January 7, 1994
Project No. RC0019.008

SUBJECT: Conceptual Remedial Approach
Former Penske Truck Leasing Company Facility
725 Julie Ann Way, Oakland, California.

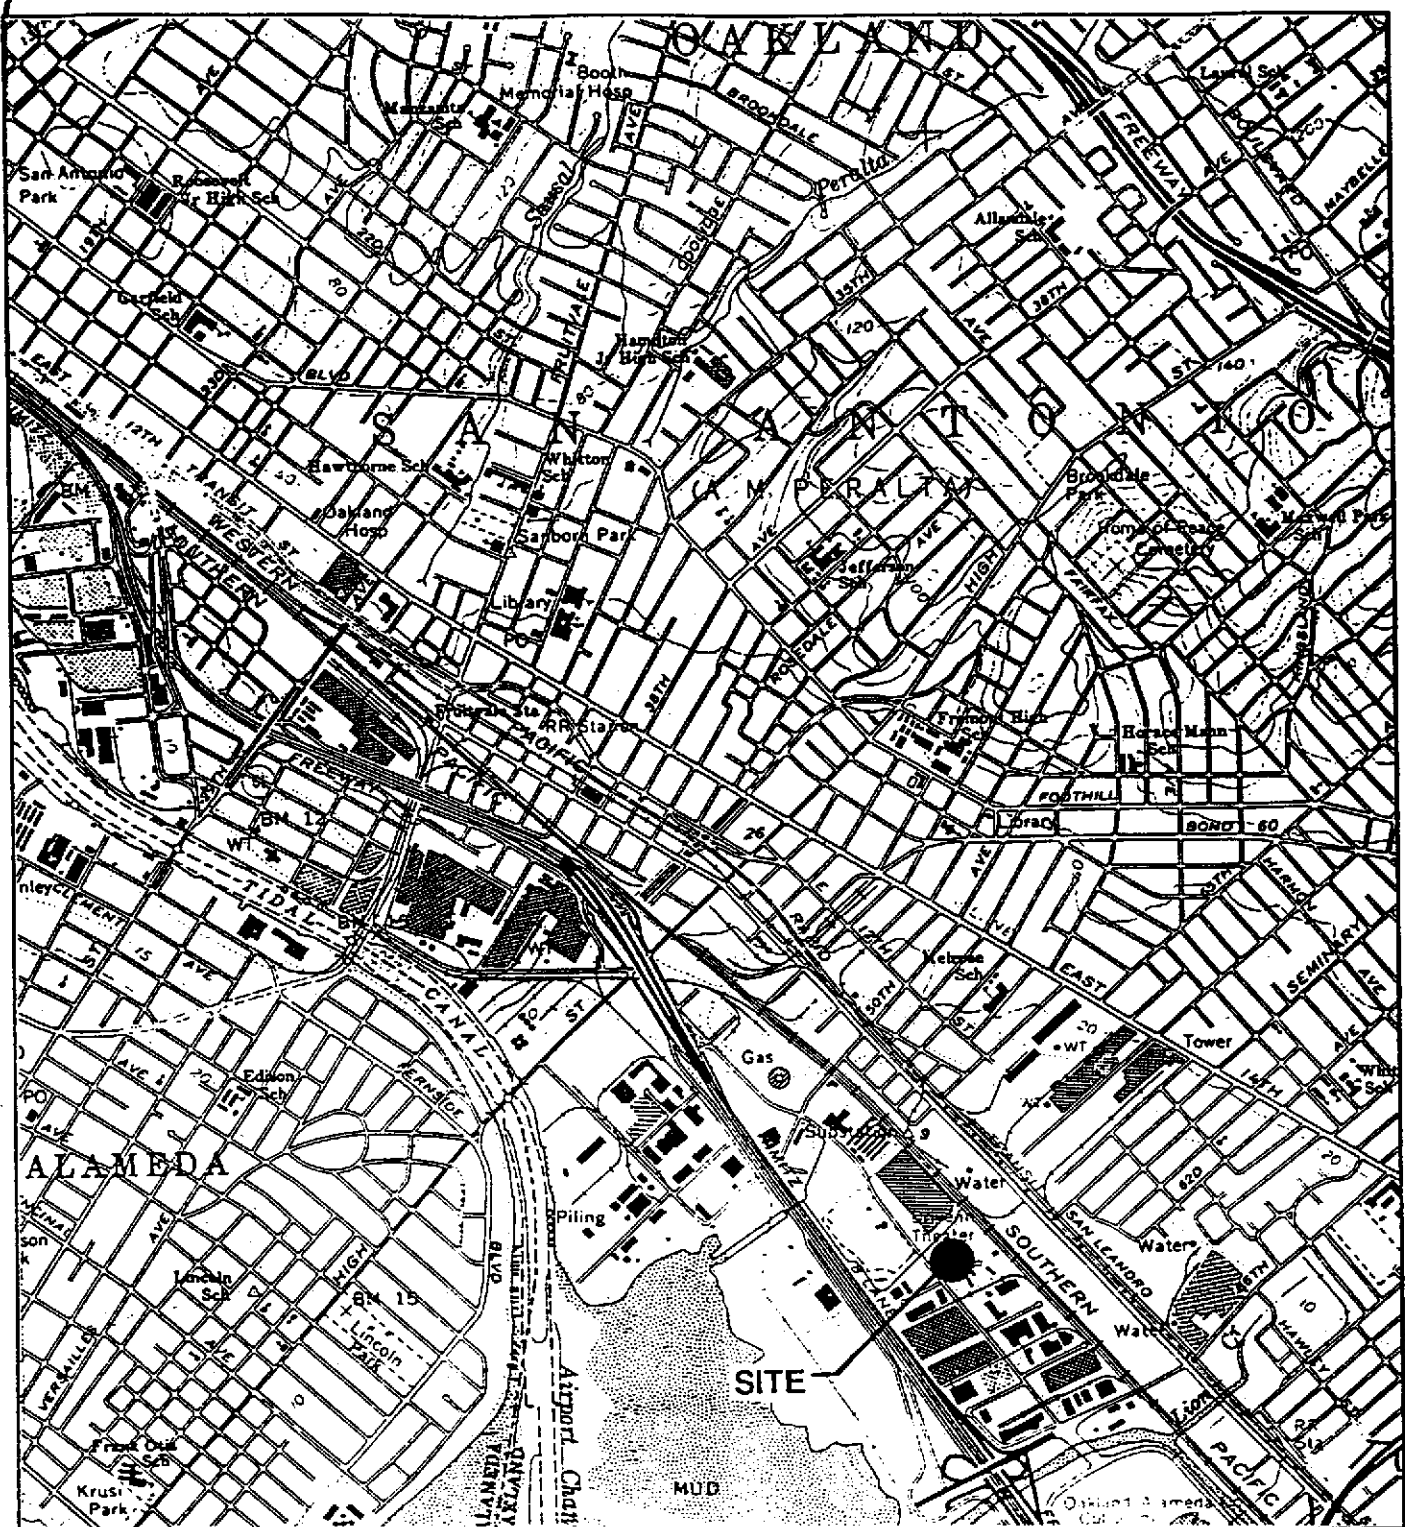
need to run GC/MS to verify no carcinogenic Semi-volatiles exist

Big

J.M.

5,000 ppb

No
